DOMINION VIRGINIA POWER
NORTH ANNA UNIT 3 COMBINED LICENSE APPLICATION
SRP 02.05.02: RESPONSE TO RAI LETTER 53

RAI 5198 Question 02.05.02-1

RAI NO.: 5198 (RAI Letter 53)

SRP SECTION: 02.05.02 – VIBRATORY GROUND MOTION

Figure 1. Best Estimate Shear Wave Velocity Profile for GMRS Calculation

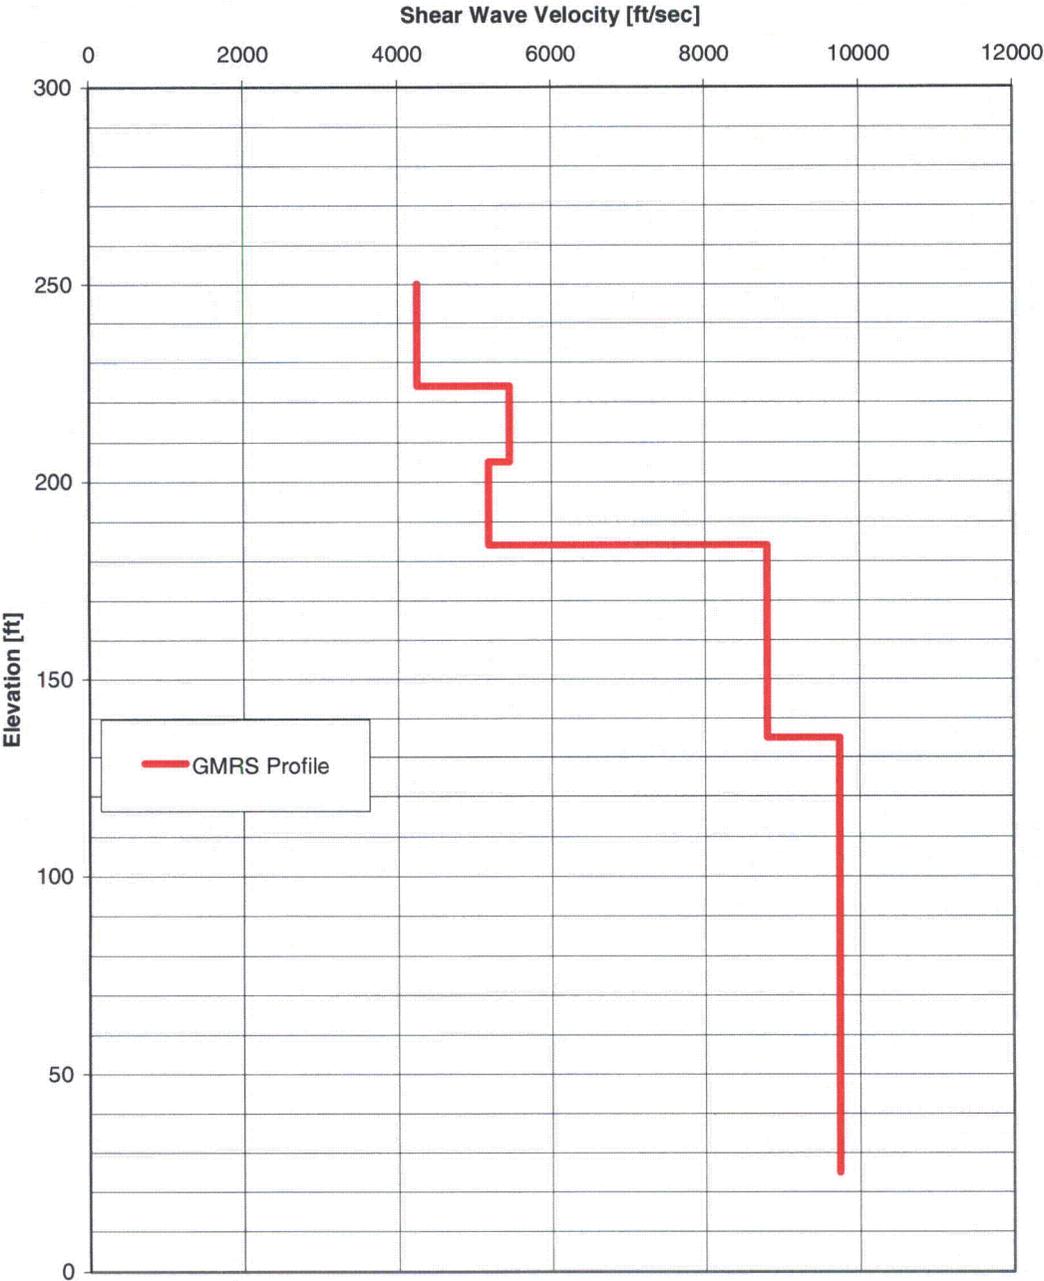
As the weathered rock above the hard rock interface has a V_s less than 9200 ft/sec, please provide the base V_s profile along with a complete description of the site response analysis to determine the GMRS for the site.

After discussions with the NRC on this topic, Dominion has decided to revise the current location of the Ground Motion Response Spectra (GMRS) provided in FSAR Section 2.5.2.5 from Elevation 145 ft to a free field hypothetical outcrop at Elevation 250 ft. (Note that the elevation of 135 ft below finished grade is incorrectly stated in the above question. Also, all elevations provided within are with respect to NAVD 88 and that the design plant grade is at Elevation 290 ft.) At Elevation 250 ft, the top layer of the rock column is Zone III-IV material, a moderately weathered to slightly weathered rock. The Shear Wave Velocity (V_s) profile for the site response analyses is provided in Figure 1. Elevation 250 ft corresponds closely to the bottom of the foundation of the Reactor

Building Complex (R/B) and the Power Source Buildings (PS/Bs). The actual foundation bases are at Elevation 251 ft. This is the lowest foundation elevation of the Seismic Category I structures. Note that for the R/B and the PS/Bs [as well as the Power Source Fuel Storage Vaults (PSFSVs)], the excavation will be extended below the bottom of each foundation elevation to remove and replace the Zone II and Zone III material with lean concrete fill. The revised GMRS is calculated as a geologic outcrop response spectra in accordance with the guidance specified in ISG-17 and RG 1.208.

Figure 2. Revised Horizontal GMRS for NA3

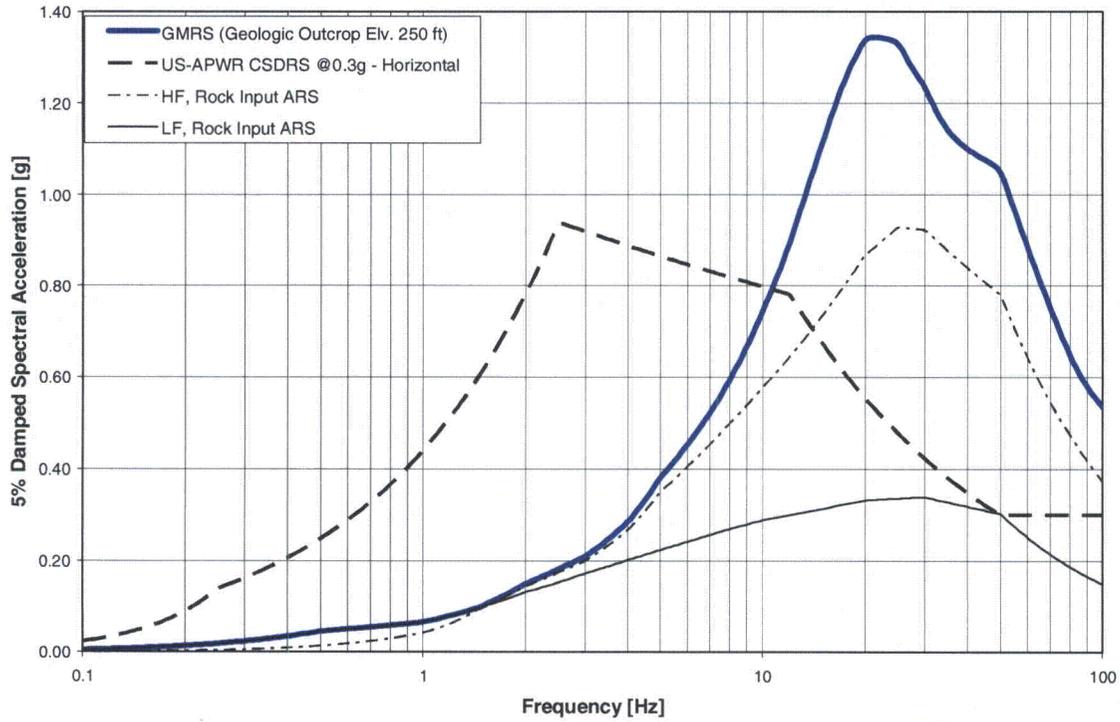
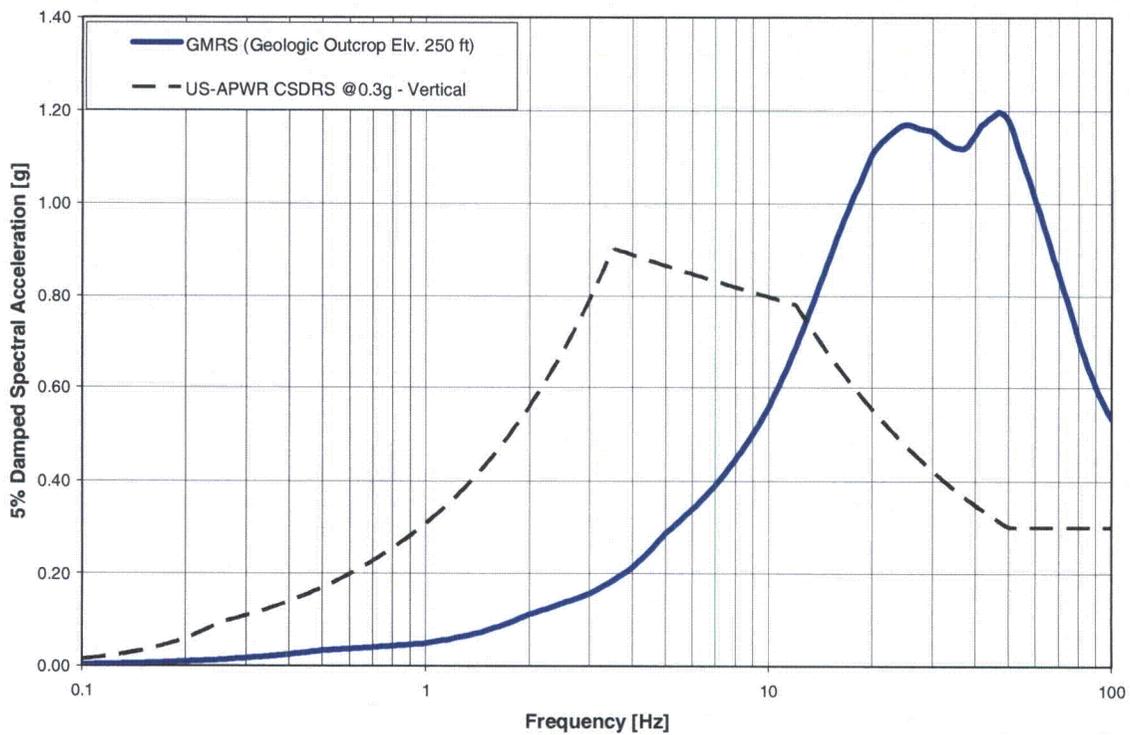
FSAR Section 2.5.2.5 states that the GMRS is defined at a site elevation of 135 ft below finished grade at the hard rock interface ($V_s = 9200$ ft/sec). Justify that this location for the GMRS is consistent with the description of the SSE found in 10 CFR 100.23(d)(1) and the location of the GMRS as specified in ISG-17 and RG 1.208, which states that

The new GMRS will be reflected in a revision to FSAR Table 2.5-201 and Figure 2.5-201. The revised horizontal and vertical GMRS are presented in Figure 2 and Figure 3, respectively. For comparison purposes the LF and HF input rock spectra (for horizontal direction only) as well as the U.S. APWR CSDRS are also shown in these figures. The numerical values for the horizontal and vertical GMRS at selected frequencies are provided in Table 1.

Figure 1 - Adopted Best Estimate Shear Wave Velocity Profile

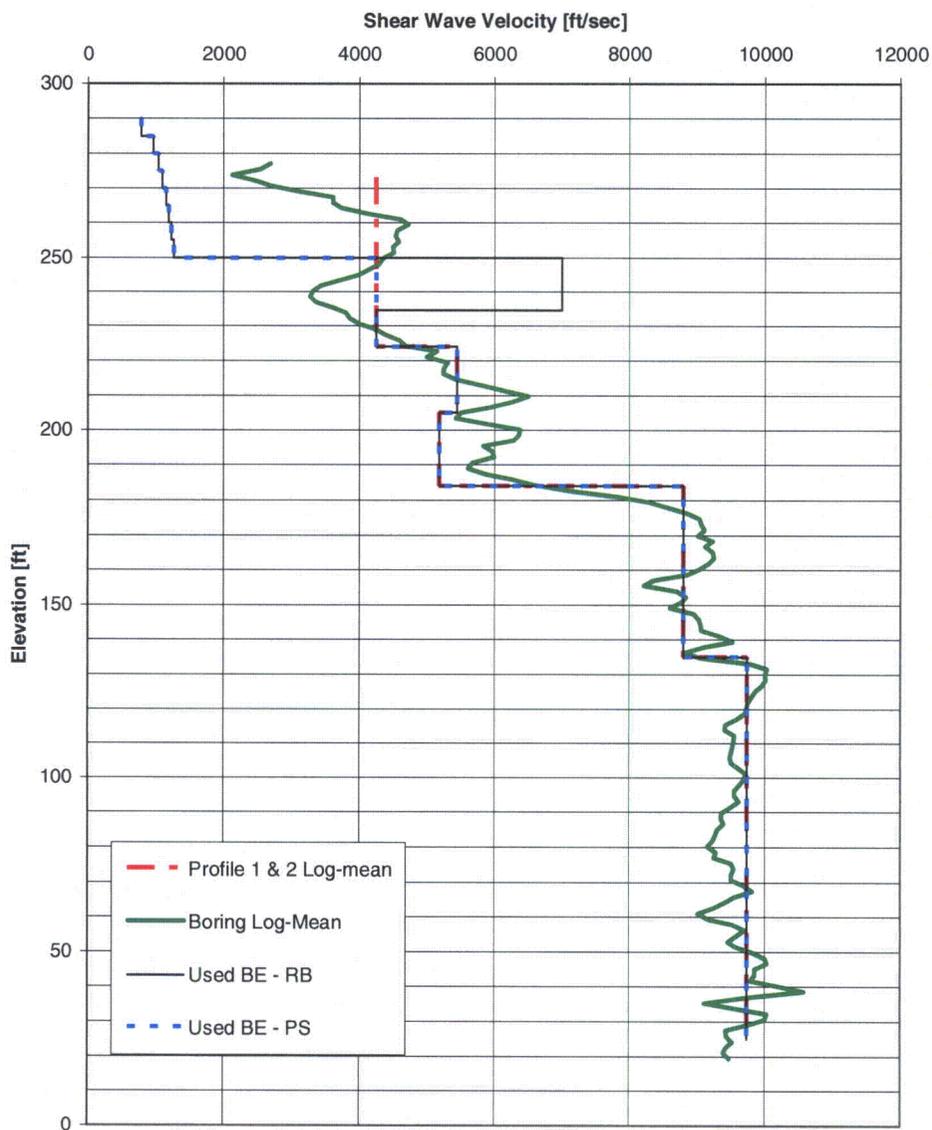
- a) Please justify the assumption of uniformity of layers based on available borings and shear-wave velocity profiles in relation to applicability of 1-D methods such as SHAKE and P-SHAKE to determine the North Anna site amplification.
 - b) Please describe how the site response analyses for the FIRS and GMRS will adequately capture the significant variability in the top of competent rock across not only the site, but also across the footprint of the Reactor Building and other seismic Category I structures.
-

The shear wave velocity profile in Figure 1 was obtained from the three V_s borings within and close to the R/B footprint (B-901, B-907 and B-909 in FSAR Figure 2.5-237). The log mean of this V_s profile is shown in Figure 1. This figure also shows the best estimate of the shear wave velocity used for the R/B (bold solid line). It shows the backfill (V_s of around 1,000 ft/sec) from grade at El. 290 ft down to the foundation base at El. 251 ft, then 15.5 ft of concrete at average V_s of 7,000 ft/sec, underlain by Zone III-IV and then Zone IV bedrock.
